Submissions and Preferred Infrastructure Report

Albion Park Rail bypass

SUBMISSIONS AND PREFERRED INFRASTRUCTURE REPORT

Report No FCIA0001-APRB-R-13

Figure 5-9 Croom Regional Sporting Complex master plan

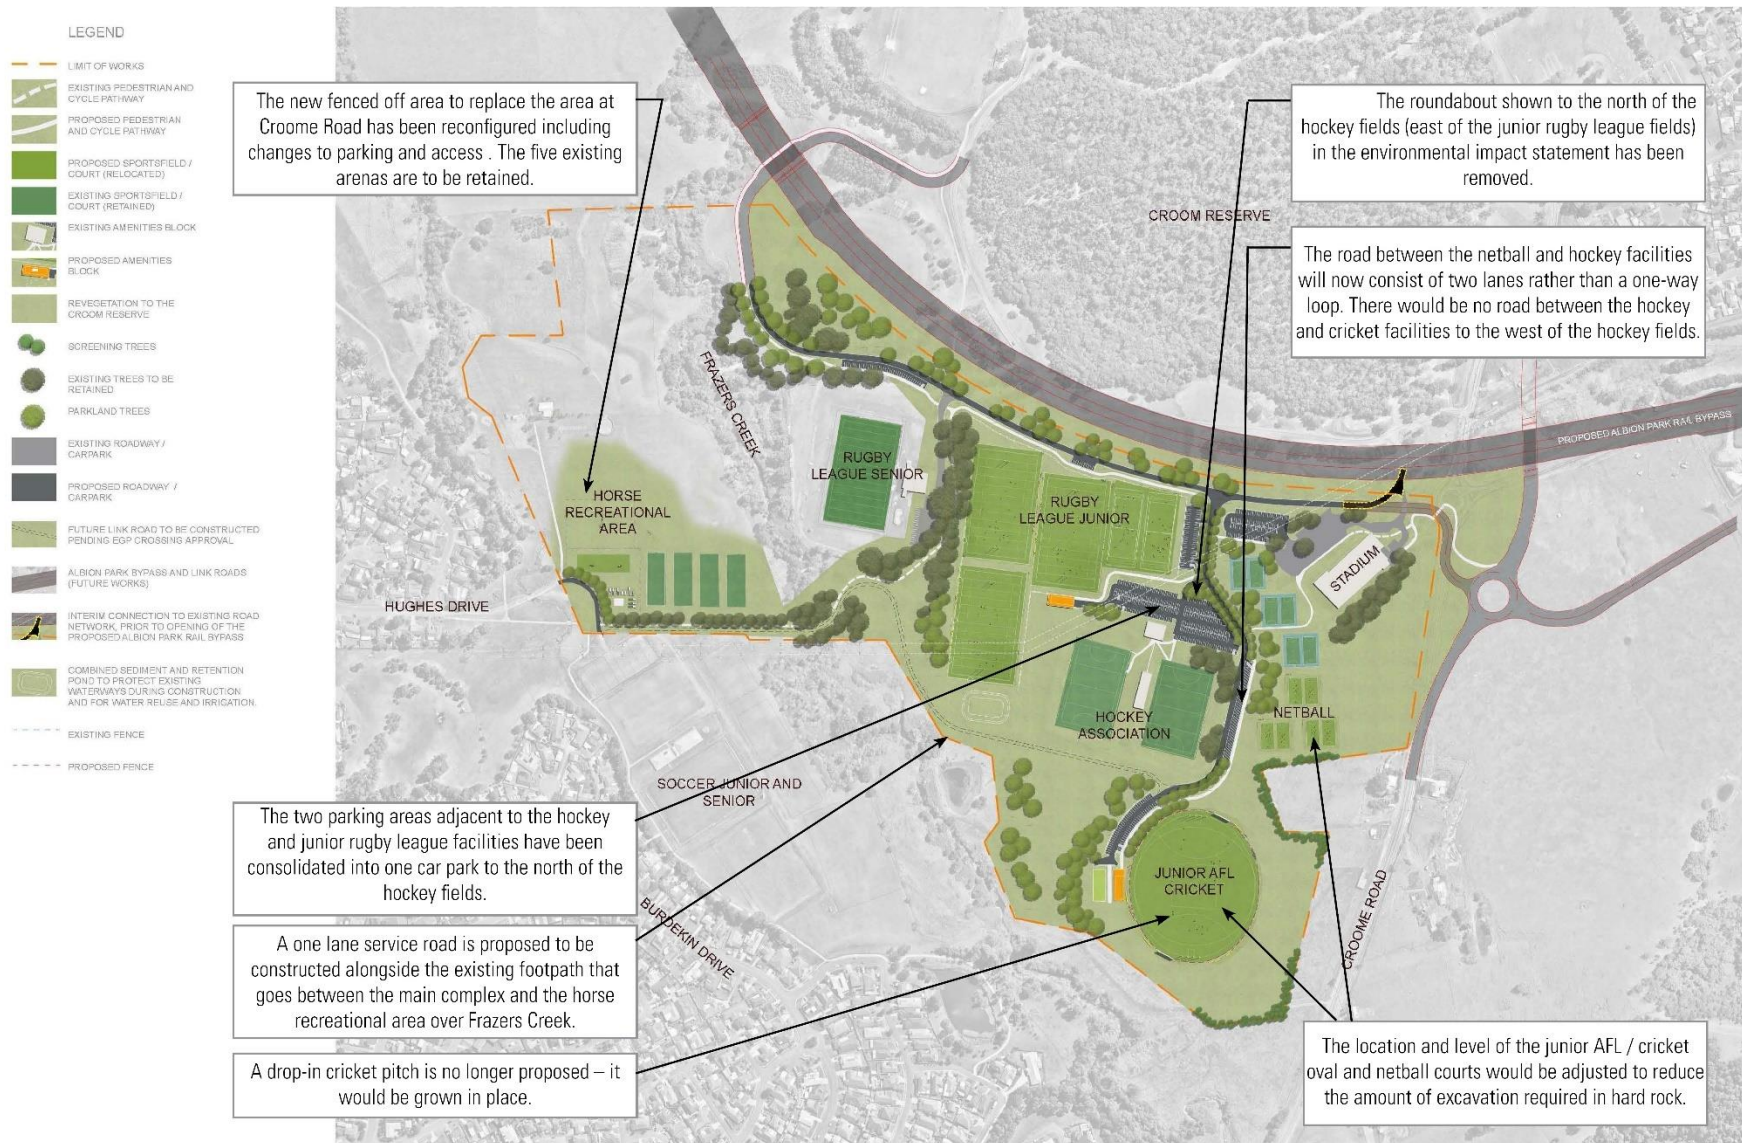
As identified in the submission, Roads and Maritime has worked closely with Shellharbour City Council (the facility owner), and the sporting groups that use the facilities, to develop a master plan for reconfiguring the Croom Regional Sporting Complex. A revised version of this master plan is included in Figure 5-9 of this report.

Since the exhibition of the environmental impact statement, the proposed design for the sporting complex has been refined in an updated master plan for the site (Figure 5-9). The proposed changes include:

The Croom Regional Sporting Complex master plan has been updated and is included in Figure 5-9.

Figure 5-13 Level of service for Oak Flats interchange, 2041

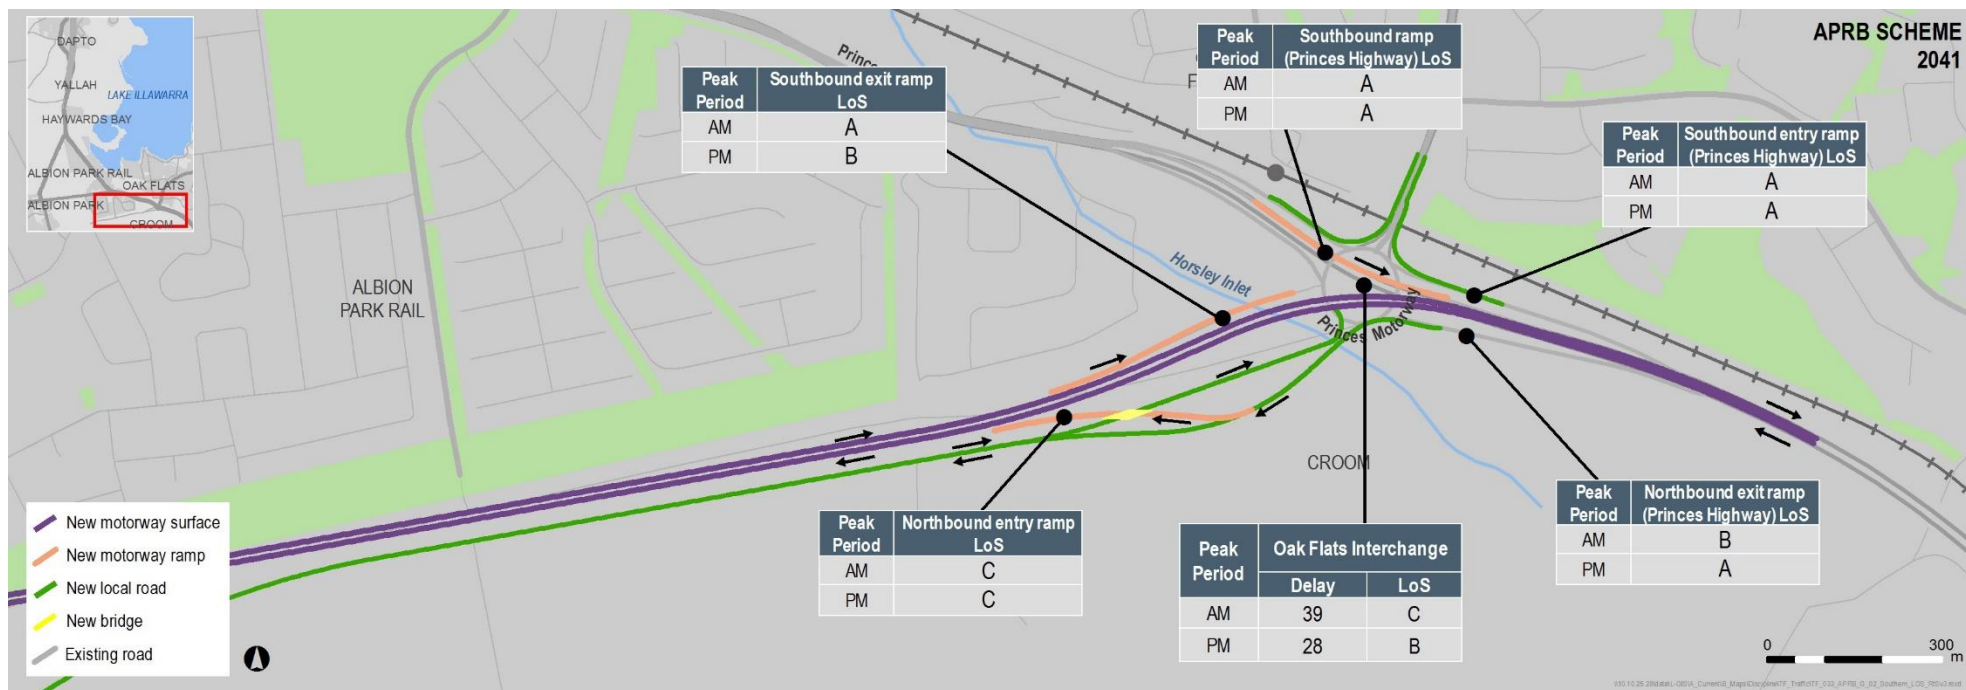
The community's concerns about the potential for traffic to queue at the Oak Flats interchange northbound exit ramp are noted. The detailed traffic modelling undertaken as part of the design refinement process identifies that the northbound exit ramp from the Princes Motorway onto the Oak Flats interchange would need two lanes. The design has now been changed to adopt the two lane exit northbound and this ramp would maintain a level of service of B or better by 2041 (refer Figure 5-13 of this report). It is not anticipated that any substantial queuing would occur with the adoption of two lanes at the northbound exit ramp by 2041.

Figure 5-13 of this report summarises the estimated levels of service for the Oak Flats Interchange. The community's concerns about the potential for traffic to queue at the Oak Flats Interchange northbound exit ramp are noted. The detailed traffic modelling reported in Appendix A of this report identifies that the Oak Flats Interchange roundabout would operate at an overall level of service C for the AM peak and level of service B for the PM peak period. It is not anticipated that any queuing would occur even with the adoption of a single lane at the northbound exit ramp. Traffic congestion through the Interchange is not anticipated to act as a deterrent to people entering Albion Park Rail.

Results of the updated 2041 design year modelling for the Oaks Flat interchange are shown in Figure 5-13 and summarised as follows:

- The Oak Flats Interchange's critical movement would operate at level of service C in the AM peak and level of service B in the PM peak period. None of the approaches experience average delay greater than 70 seconds, a threshold deemed to be appropriate for this case. The majority of road users are expected to experience average delays at this intersection of under 40 seconds during the AM peak and below 30 in the PM peak period. There are a number of ways that this intersection could be optimised to improve the performance. It is proposed that the interchange layout be further investigated during the project detailed design phase.

Figure 5-18 Flood immunity on the proposed Albion Park Rail bypass

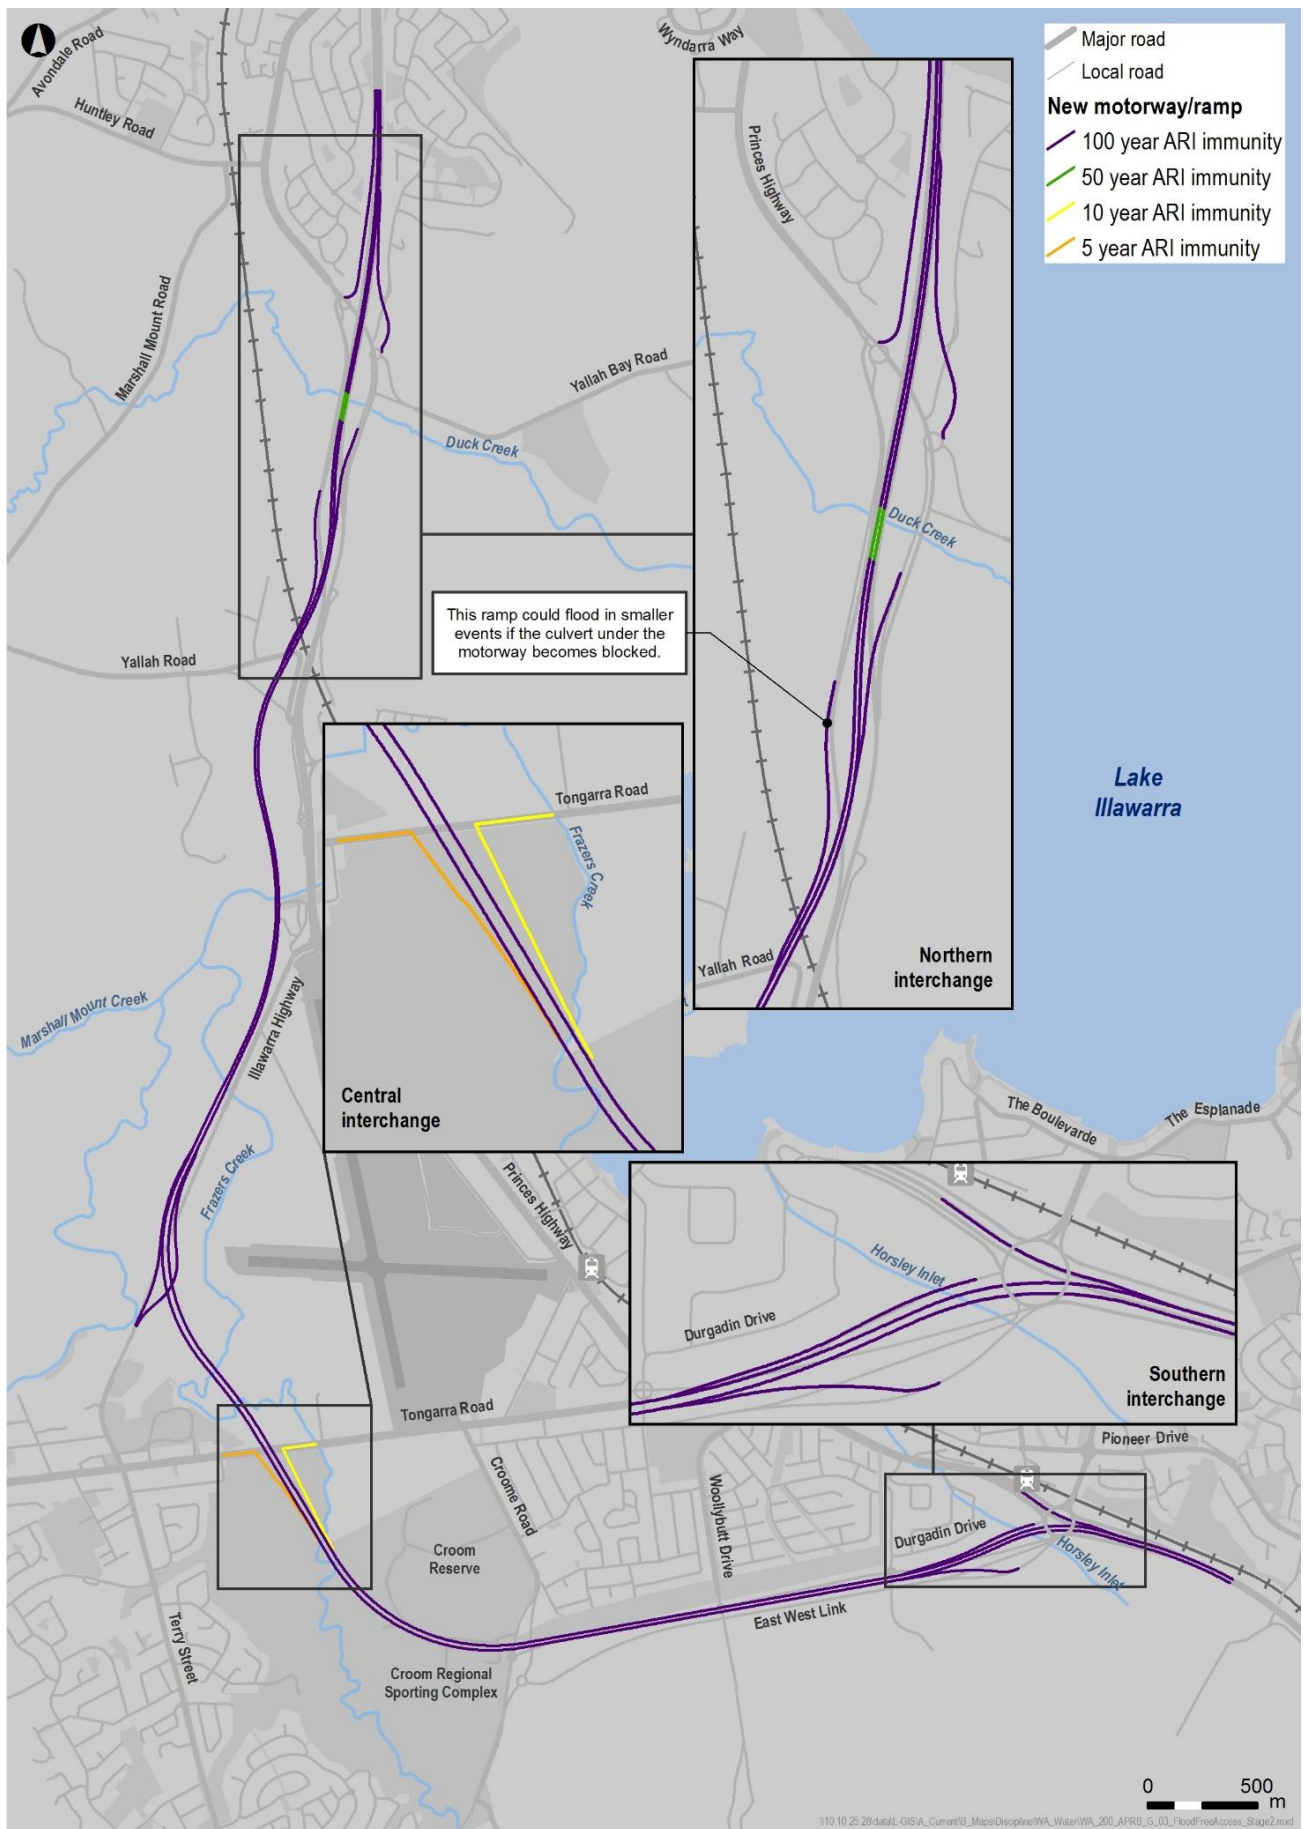
There is one section of the main carriageway, around 160 metres long near the Duck Creek bridge (BR01 in Figure 5-1 of this report), at which two of three northbound lanes would be inundated to a depth of up to 0.25 metres in the 100 year ARI flood event (refer Table 6-1 of Technical Paper 3 – Hydrology and Flooding). This section would be flood free in the 50 year ARI flood. The road level of the main carriageway could not be raised higher in this location due to the need to tie into the level of the existing bridge, which is currently inundated in the 100 year ARI flood event. In the event of a flood of this magnitude, this section of the bypass would be classified as being low hazard under the Floodplain Development Manual (Department of Infrastructure, Planning and Natural Resources, 2005) and would remain passable for emergency vehicles.

There are several constraints that limit the ability of the project to achieve this level of immunity. As described above, the need to tie into the existing bridge at BR01 (Figure 5-1 of this report) means the bypass cannot be raised above the 100 year ARI flood level. There is also the need to achieve a balance between avoiding negative impacts on surrounding infrastructure and maximising the flood immunity of the project. These may be incompatible objectives; for example, further maximising the flood immunity of the project would require incursions into the airspace requirements for the Illawarra Regional Airport therefore affecting the flightpath of aircraft take-off and landing. This would have an overall impact on future aircraft operations, compared to the existing situation. There are also a range of other environmental aspects that need to be considered, and the design has been optimised in terms of the feasible level of flood immunity that could reasonably be achieved.

The environmental impact statement states the project would reduce the area of high ground available for cattle to shelter during a flood. In a 20 year ARI event, the area of flood free land between the Illawarra Highway and Macquarie Rivulet is reduced from 7.6 hectares to 3.6 hectares (up from 3.3 hectares in the environmental impact statement) as a result of the project. It is noted that this reduction in flood free area is primarily due to the land required for the project, not due to changes in the flood extent.
